**RFP# 4238 - Addendum #2  
Roof Replacement and Localized Envelope Repairs  
Rockingstone Heights School**

To: All Bidders  
Date: June 14, 2024  
From: Nancy Rideout, Purchasing Manager  
Office: (902) 464-2000 ext. 2222  
Email: [nrideout@hrce.ca](mailto:nrideout@hrce.ca)

**The bid documents shall be amended, and new drawings and clauses added, and shall become part of the contract documents as follows:**

TITLE: ROOF PLAN (REV. 2)	
CLIENT: HALIFAX CENTRE FOR EDU.	
PROJECT: ROCKINGSTONE HEIGHTS 1 REGAN DRIVE HALIFAX, NS	
IRC #: 26554	PROJECT NORTH:
W.O.#: NB24-007SP	 (TRUE NORTH)
SCALE: 3/64" = 1'-0"	
DATE: JUNE 6, 2024	DWG.#:
DRN. BY: J.S.	R1
CHK. BY: M.M/V.A.

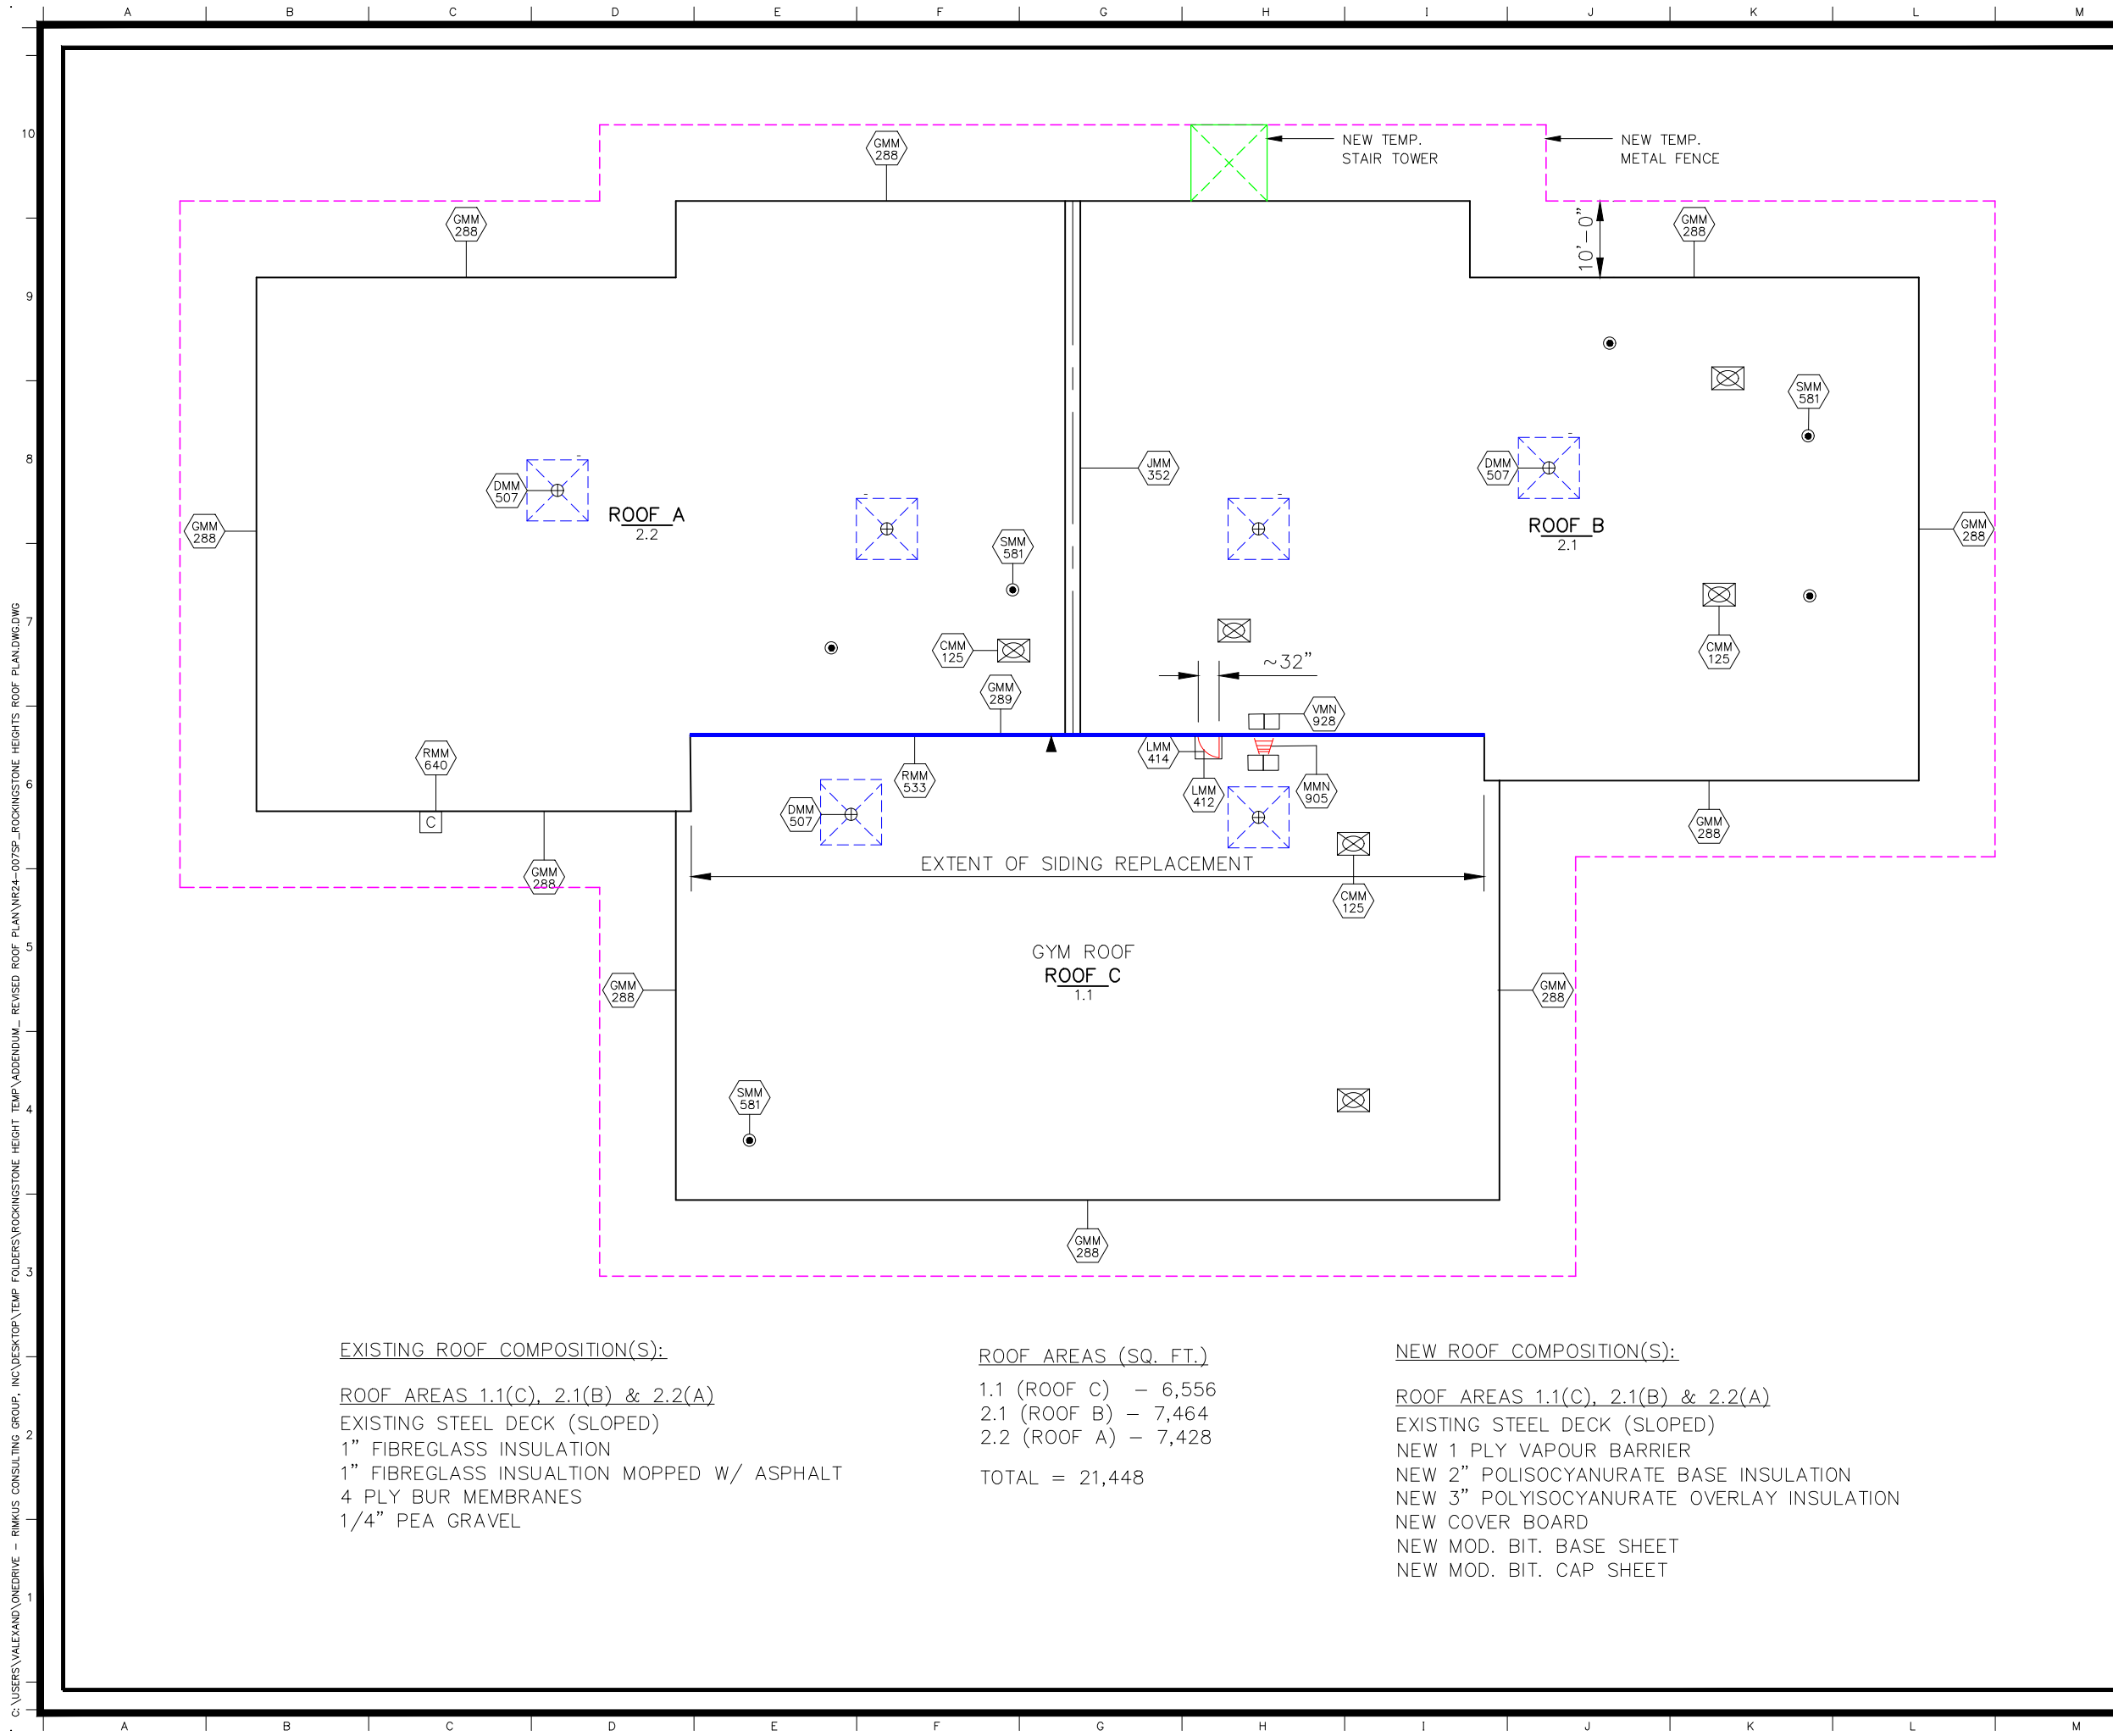
- 3.1 Remove existing roof plan R1 and replace with new roof plan R2 – Rev. #2, dated June 6<sup>th</sup>, 2024.
  - .1 Changes to new roof plan include addition of three (3) drains, new temporary fencing placement, new stair tower placement, new door width dimension, placement of platform, updated label on roof 1.1, and two (2) new detail tags.
- 3.2 Remove detail LMM 412 and replace with LMM 412 Rev #2, dated June 6<sup>th</sup>, 2024.
- 3.3 Add new drawing LMM 414 – Door Head Detail
- 3.4 Add new drawing GMM 289 – Edge & Siding Detail

TITLE:	DOOR SILL DETAIL		REVISED:		SCALE:	3" = 1'-0"
				REV'N.#:	2	DATE:	JUNE 6, 2024
	NOTE:	NO REPRODUCTION OR USE OF THIS DRAWING IS AUTHORIZED WITHOUT EXPRESSED WRITTEN CONSENT		DRN. BY:	J.S.	DWG.#:	LMM412
		© 2024 RIMKUS CONSULTING GROUP		CHK. BY:	M.M./V.A.

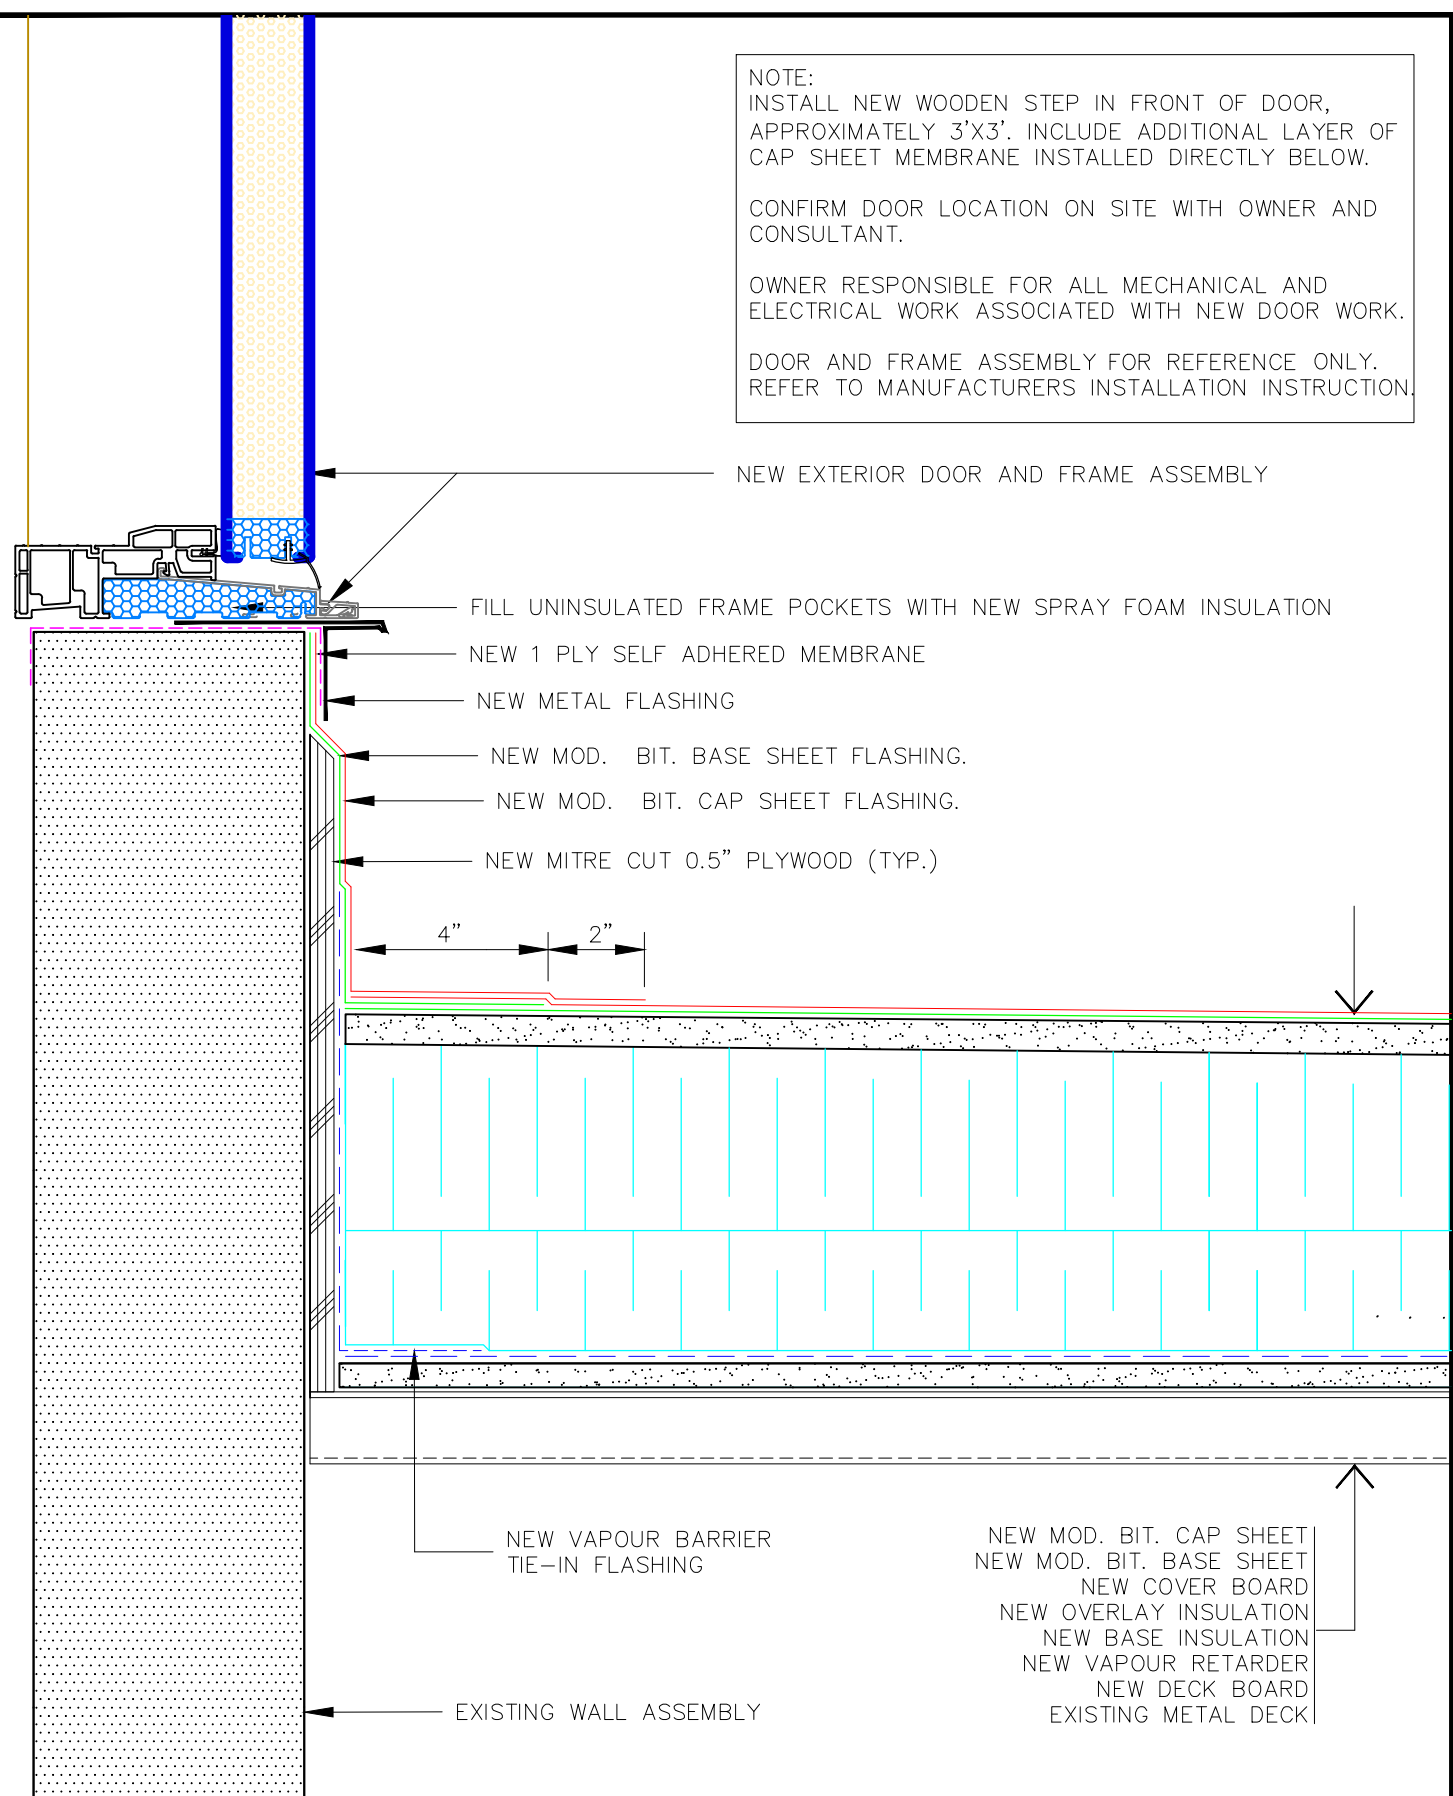
- .1 New door rough opening dimensions to be 32" x 72". Door location to be verified by Owner prior to install. See detail LMM 412 Rev. 2 and LMM 414.
- .2 Contractor to supply and install new 3'x3' pressure treated wood platform in front of new exterior door. Platform to be stable, level, and adequately supported. Wood joist framing @ 12" o.c. with 2x4 wood surface decking. New additional protection membrane (1 ply cap sheet) to be installed below entire wood platform. Surface height of new platform to be standard height which meets typical code requirements for stairs. Review and verify new platform height with Consultant on site.

NOTE:  
 INSTALL NEW WOODEN STEP IN FRONT OF DOOR, APPROXIMATELY 3'X3'. INCLUDE ADDITIONAL LAYER OF CAP SHEET MEMBRANE INSTALLED DIRECTLY BELOW.

CONFIRM DOOR LOCATION ON SITE WITH OWNER AND CONSULTANT.
